# Access Compliance Report

## Public Rights-of-Way

### (Curb Ramps)

Intersection ID: 10040955	Main Street: WALNUT_FOREST_DR	Cross Street: N/A	Location: SE
ADA ID: 50E15C8EEE78	Ramp Type: Perp	Initial Pass/Fail: Fail	Overall Compliance: No
Codes/Mitigation Info/Possible Solution		Field Measurements/Component Compliance	
Severity Score: 8.75

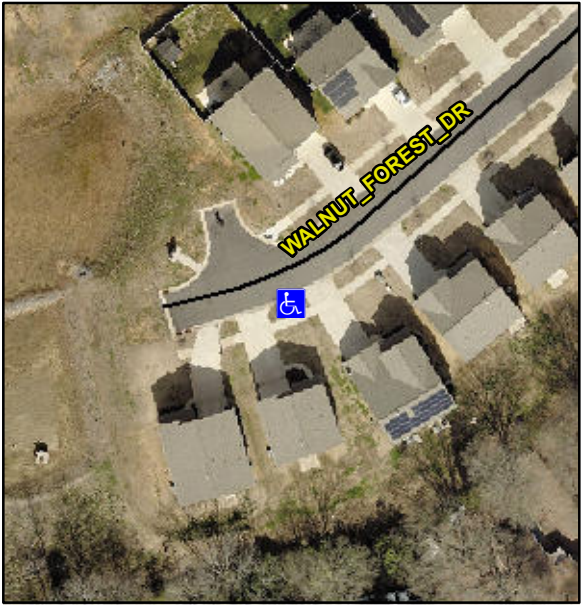
Possible Solutions:	Compliance	Description	Data	Compliance	Description	Data
	Remove & Replace Entire Ramp.	N/A	Ramp Length (in)	96.0	Yes	Ramp Slope (%)	6.7
		No	Ramp Width (in)	47.0	Yes	Ramp XSlope (%)	0.7
		N/A	Flare Type LT	N/A	N/A	Flare Type RT	N/A
		N/A	Flare Slope LT (%)	N/A	N/A	Flare Slope RT (%)	N/A
		N/A	Flare Traversable LT?	N/A	N/A	Flare Traversable RT?	N/A
		N/A	Landing Length (in)	N/A	N/A	DWS Provided?	N/A
		N/A	Landing Width (in)	N/A	N/A	DWS Contrast?	N/A
		N/A	Landing Slope (%)	N/A	N/A	DWS Length (in)	N/A
		N/A	Landing X Slope (%)	N/A	N/A	DWS Full Width?	N/A
<p>Surveyor Notes:</p> <p>N/A</p> <p>PROW/ADA:</p> <p>Not Found, R304.5.1</p>		N/A	Landing Curb? (Y/N)	N/A	N/A	DWS Offset (in)	N/A
		N/A	Shared Landing?	N/A			
		N/A	Gutter Ponding?	N/A	N/A	Gutter Slope (%)	N/A
		N/A	Gutter Lip Ht (in)	1.0	N/A	Gutter X Slope (%)	N/A
		N/A	Painted X Walk1?	No	N/A	Painted X Walk2?	N/A
			X Walk 1 Direction	To N		X Walk 2 Direction	N/A
